## HANDSETS

### G1,G2,G3,G4, AND G5 TYPES

#### IDENTIFICATION, MAINTENANCE, AND SCHEMATICS

1.01 This addendum supplements Section 501-210-102. It is re-issued to add Paragraph 1.02, 1.03, 4.02, and to change Paragraph 3.04 and add information to 2.22.

FIG. 1

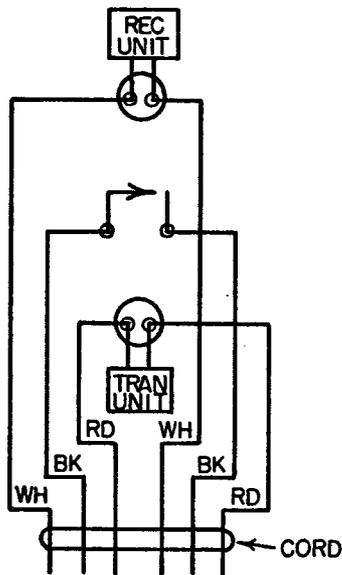
4.02 For connections of G5KR handset to 500, 600, or 700 type sets, use Table A and Figure 1 of this addendum.
